AR-07-1162

Southern Nuclear Operating Company
Vogtle Early Site Permit Application
Supplemental Response to Requests for Additional Information on Geology/Seismology

Supplemental Response to Geology/Seismology RAIs

Vogtle ESP Application

Figure 2g. Hard rock (solid red line) and top of Blue Bluff Marl (dashed blue and solid green line) seismic hazard curves for 0.5 Hz.

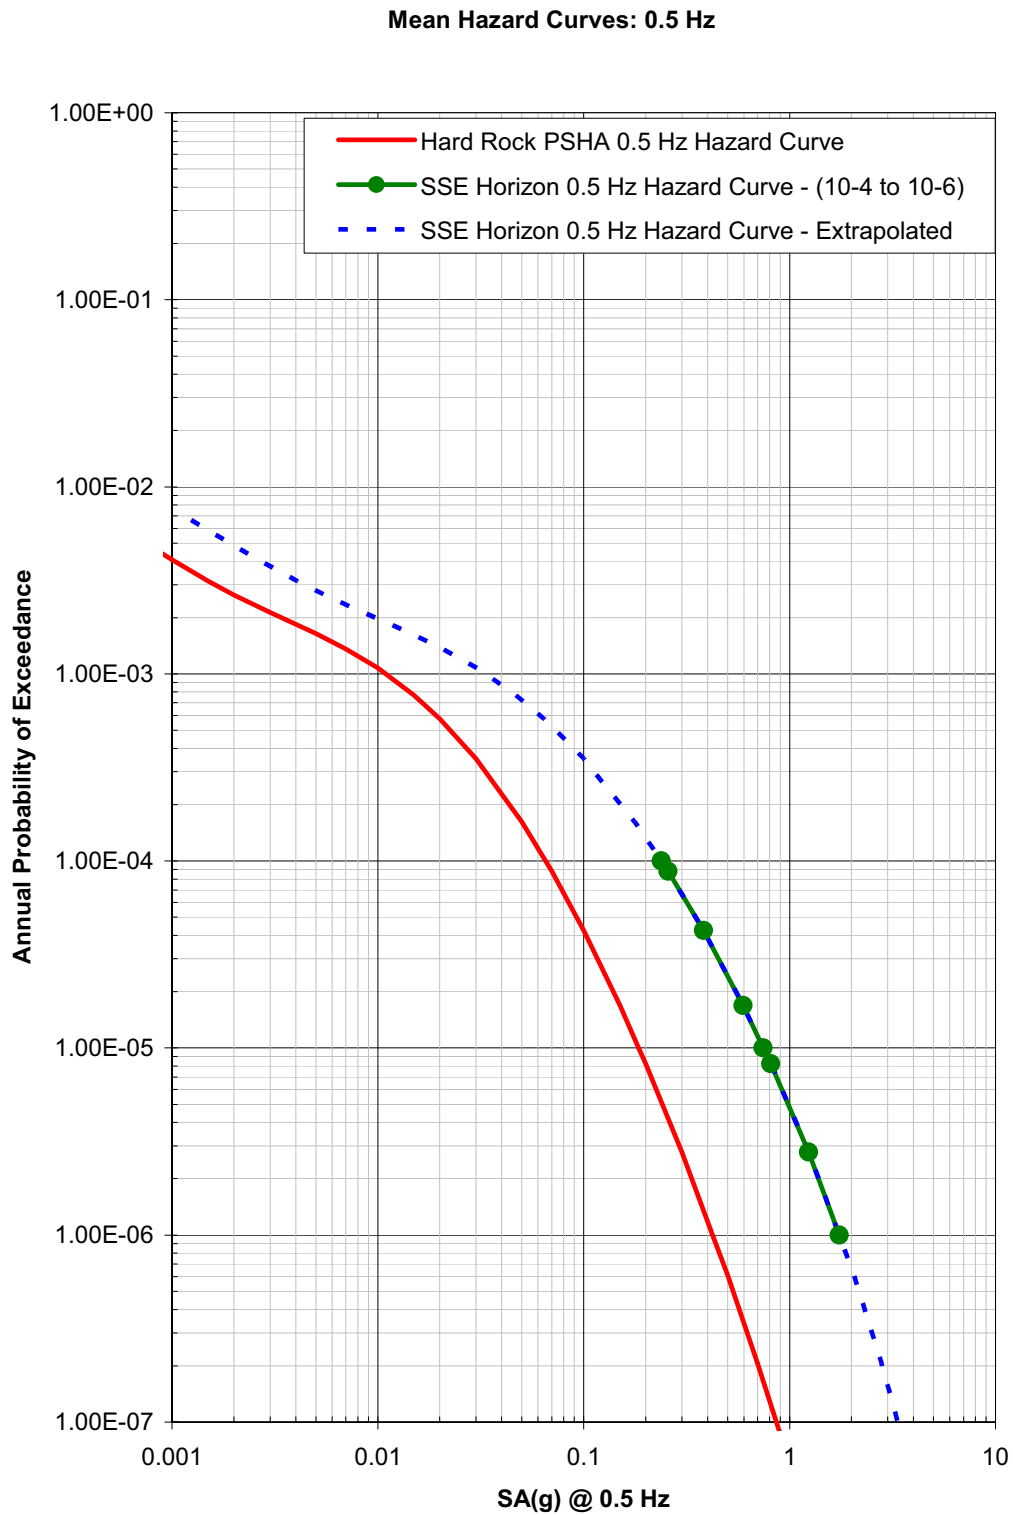
2.5.2-3 In response to this RAI, soil hazard curves were provided at three annual exceedence frequencies (10^{-4} , 10^{-5} , and 10^{-6}). However, in order for the staff to verify the adequacy of the SSE, soil hazard curves are requested at additional annual exceedence frequencies (i.e. at values between 10^{-4} , 10^{-5} , and 10^{-6}).

Next the hard rock hazard curves were scaled based on the functional amplification factor model for each frequency. The three hard rock ground motion values (see Table 1) corresponding to annual probability levels of 10^{-4} , 10^{-5} , and 10^{-6} were added to the suite of 25 points that defined the hard rock hazard curves (Risk Engineering Inc., 0521-ACR-032, 2006) prior to developing the top of Blue Bluff Marl hazard curves. For each of the seven frequencies, the top of Blue Bluff Marl seismic hazard curve was computed by scaling the hard rock ground motion values by the functional amplification model at each of the 28 annual probability level points that define the hard rock seismic hazard curves (see Table 2). A constraint was placed on the resulting top of Blue Bluff Marl hazard curves such that the resulting hazard curve does not decrease in ground motion for decreasing annual probability of exceedence levels. In cases where this constraint is applicable, the resulting top of Blue Bluff Marl hazard curve is vertical (i.e., the ground motion value is constant for decreasing annual probability levels).

The hard rock seismic hazard curves, amplification factors, and corresponding top of Blue Bluff Marl seismic hazard curves are listed in Table 2 for the seven frequencies. The three additional data points corresponding to probability levels of 10^{-4} , 10^{-5} , and 10^{-6} are indicated in bold. The hard rock (solid red line) and resulting top of Blue Bluff Marl seismic hazard curves are plotted in Figure 2. As indicated on each figure, the dashed blue line is based on the extrapolation of the amplification function beyond the range 10^{-4} to 10^{-6} and the green solid line with green circles is based on the interpolation of the amplification function over the range 10^{-4} to 10^{-6} .

Figure 2.5.2-18A: Seismicity in southeastern US and areas used to examine seismicity effects.

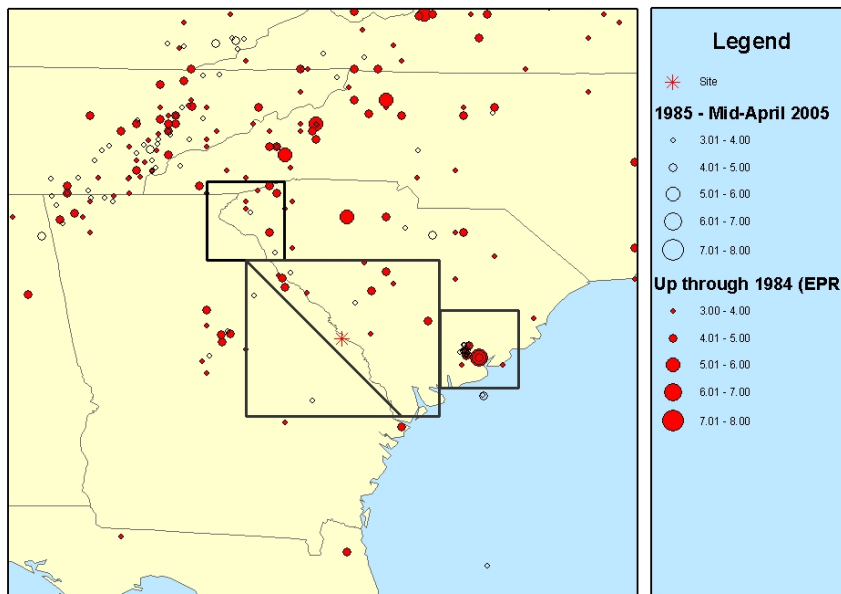
2.5.2-18 Please provide justification for the selection of the geometries shown in SSAR Figure 2.5.2-16 as well as RAI Figure 2.5.2-18A. Specifically, why were these particular geometries selected over other possible geometries? In addition, please justify the exclusion of the recent seismicity associated with the Helena Banks fault zone from all of the selected geometries.

Several areas were used to examine the effect of the new regional earthquake catalog. RAI figure 2.5.2-18A shows these areas. The areas were selected because sensitivity studies showed that seismic sources in the vicinity of the site, in the Charleston, South Carolina region, and in northwestern South Carolina were the main contributors to seismic hazard at the Vogtle site. The large rectangular source surrounding the site spans 2.5° longitude by 2° latitude, the source representing Charleston, South Carolina, spans 1° longitude by 1° latitude, and the source in northwestern South Carolina spans 1° longitude by 1° latitude. These sources were selected as representative of the regions important to seismic hazard analysis. In addition, the large source surrounding the site was divided with a diagonal line to capture seismicity in the northeast half of the source, so that seismicity would not be combined with the relatively aseismic, southwest half of the source.

All four regions showed the same result, that additional seismicity from 1985 to mid-2004 does not increase estimated activity rates in the area around the Vogtle site. As an example, RAI Figure 2.5.2-18B shows the effect of additional seismicity in the square, northwestern South Carolina source shown in RAI Figure 2.5.2-18A. The estimated activity rate decreases, similar to what is shown in SSAR Figure 2.5.2-18. We conclude that any region in South Carolina that would affect the seismic hazard of Vogtle would have estimated activity rates that stay constant or decrease, if the new regional earthquake catalog were added to the analysis.

SSAR Figure 2.5.2-37 Typical Results of Spectral Amplification at 86-ft Depth (Top of Blue Bluff Marl) Using EPRI Degradation Curves for High Frequency Time Histories of 10^{-4} MAFE Input Motion Level

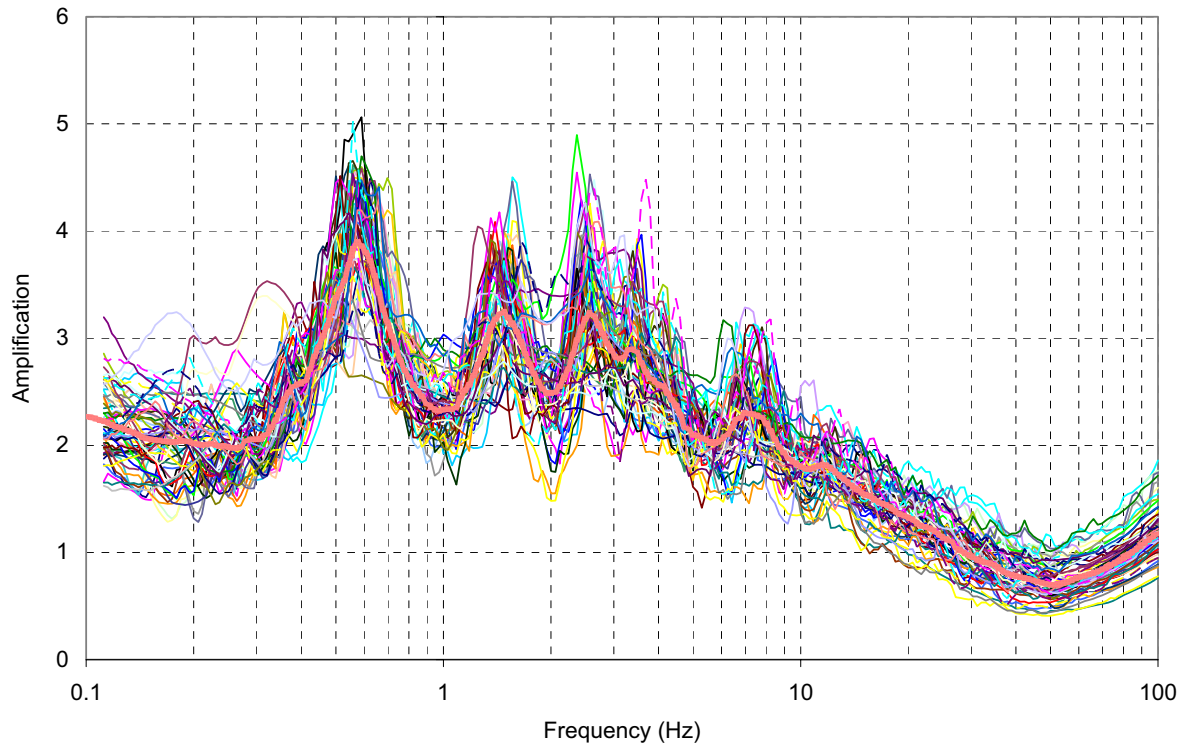
2.5.2-19 Supplement the RAI with additional information related to STEP 5. Please include a definition, and a figure (or table), of the envelope motion. The response to this RAI states

However, it is not clear if the envelope motion refers to the envelope of the mean AFs or envelope of the mean response spectra at the control point.

SSAR Figure 2.5.2-37, repeated below, illustrates the 60 individual AFs and the logarithmic mean AF across the frequency range of 0.1 Hz to 100 Hz, for the 10^{-4} MAFE, HF input, EPRI mean material curves, and 86' depth.

STEP 5B: The mean AFs for the EPRI and SRS material curves are equally weighted, to give 6 mean AFs across the frequency range 0.1 Hz to 100 Hz, for the control point horizon. These 6 mean AFs correspond to the 3 ground motion levels and to the HF and LF input motions.
